STAFF DESIGN COMMISSION REPORT

Project Name: Sigwalt Apartments
Project Address: 45 S. Chestnut Avenue
Prepared By: Steve Hautzinger

DC Number: 17-089
Petitioner Name: Michael Porto
Petitioner Address: CA Residential LLC
130 E. Randolph Street, Suite 2100
Chicago, IL 60601
Meeting Date: August 8, 2017

1. Approval of the proposed architectural design for a new multi-family apartment building.

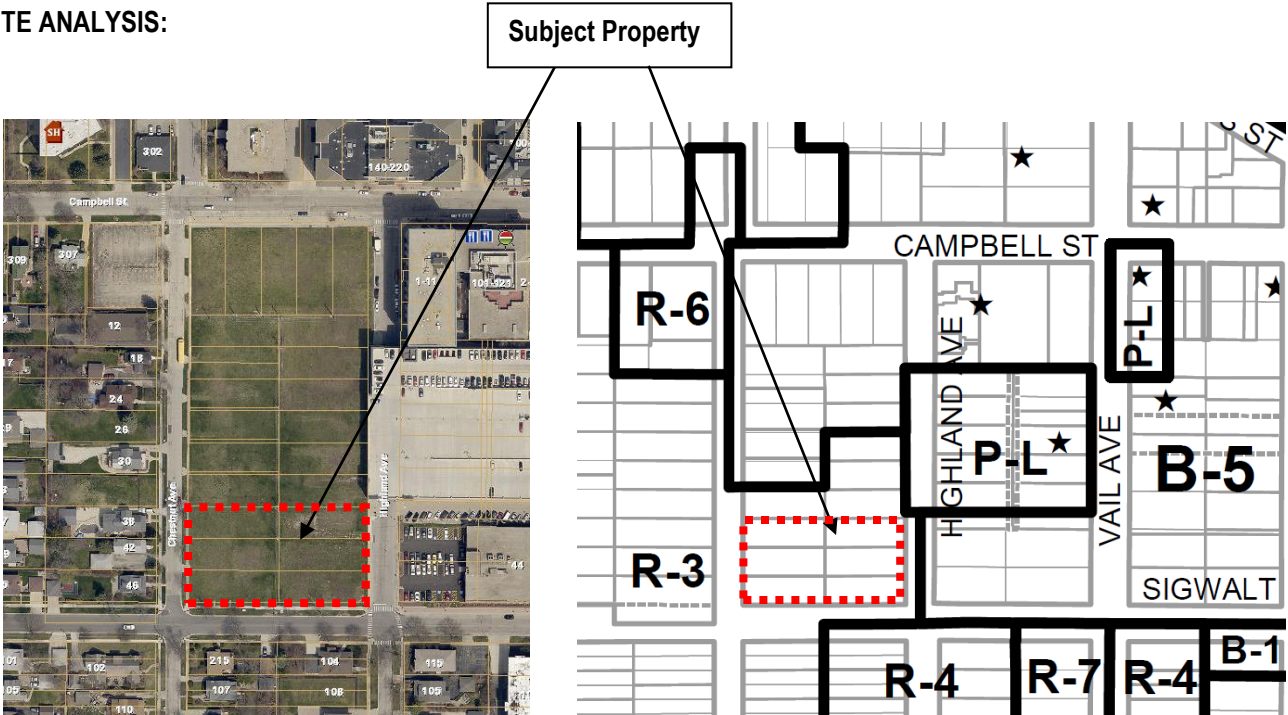
- Although there are examples of metal cladding in the Downtown, the Design Commission should evaluate the quantity and color of metal panel siding on the proposed design.
- There appears to be a lot of wall space above the top floor windows. If possible, consider lowering the height of the top floor walls one or two feet.
- Consider stepping back portions of the top floor to break down the overall mass of the building, such as recessing balconies at the outside corners.

Trash dumpsters will be stored inside the building. The exterior transformer on the east side of the building should be fully screened with landscaping or other appropriate method.

The proposed landscaping will be reviewed in detail as part of the Plan Commission review and Village Board approval, but overall the proposed landscaping is minimal and it is recommended that additional landscaping be provided. The landscaping should be layered to help soften the proposed building. Specialty paving should be considered at the main entrance.

1. Evaluate the quantity and color of metal panel siding.
2. If possible, consider lowering the height of the top floor walls one or two feet.
3. Consider stepping back portions of the top floor to break down the overall mass of the building, such as recessing balconies at the outside corners.

4. Fully screen the exterior transformer with landscaping or other appropriate method.
5. Provide additional landscaping throughout the site, in a layered design to soften the proposed building.

6. Consider adding specialty paving at the main entrance.
7. This review deals with architectural design only and should not be construed to be an approval of, or to have any other impact on nor represent any tacit approval or support for the proposed land use or any other zoning and/or land use issues or decisions that stem from zoning, building, signage or any other reviews. In addition to the normal technical review, permit drawings will be reviewed for consistency with the Design Commission and any other Commission or Board approval conditions. It is the architect/homeowner/builder's responsibility to comply with the Design Commission approval and ensure that building permit plans comply with all zoning code, building permit and signage requirements.
